HISTORIC PRESERVATION DESIGN REVIEW

HP-11-16, 49 S. Main St. (City)

The applicant is requesting Historic Preservation Design Review approval for exterior renovations to the building on property located at 49 S. Main St. and represented by Tax Map # 228-13-07-057.

2010 HR Survey Record: Site # 1256, 49 S. Main St., Sumter CBD

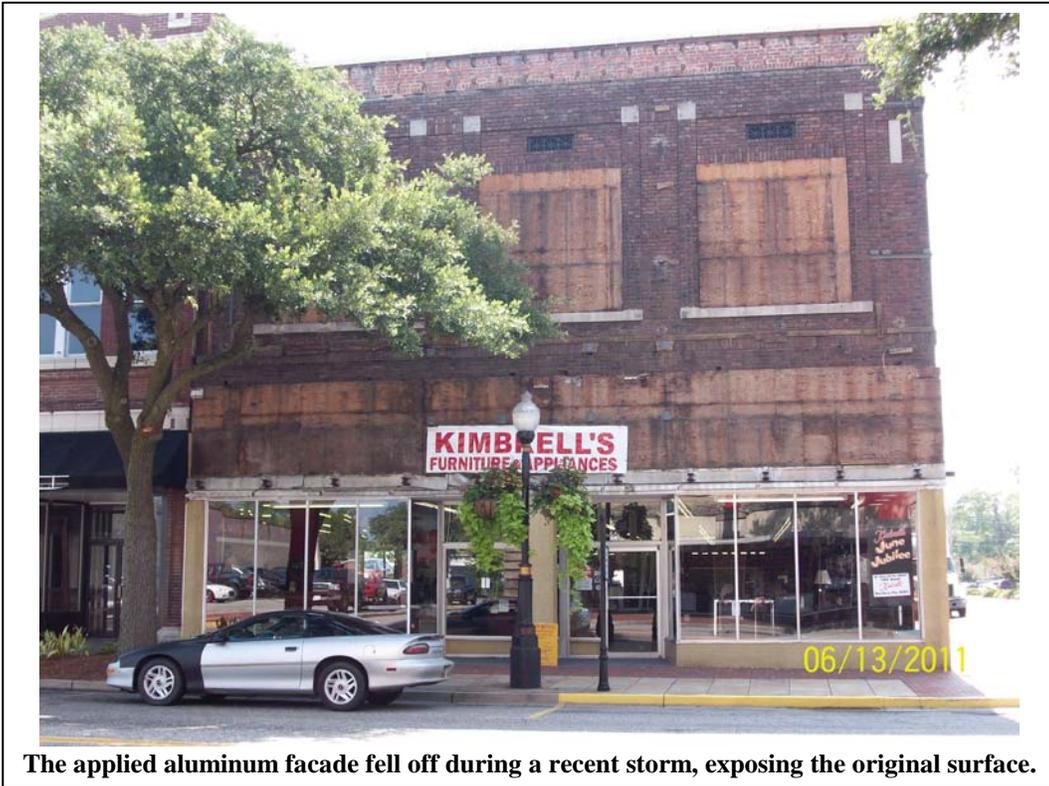
The three-story building is rectangular in shape with a flat roof surrounded in the front by a parapet wall. The façade was altered in the mid-20th century with an applied aluminum and glass storefront. The upper-level façade was damaged and fell during a recent windstorm, and has resulted in the application for this renovation.

The photograph below documents the exterior as it appeared prior to the removal of the 20th-century aluminum façade.

The applied aluminum facade fell off during a recent storm, exposing the original surface.
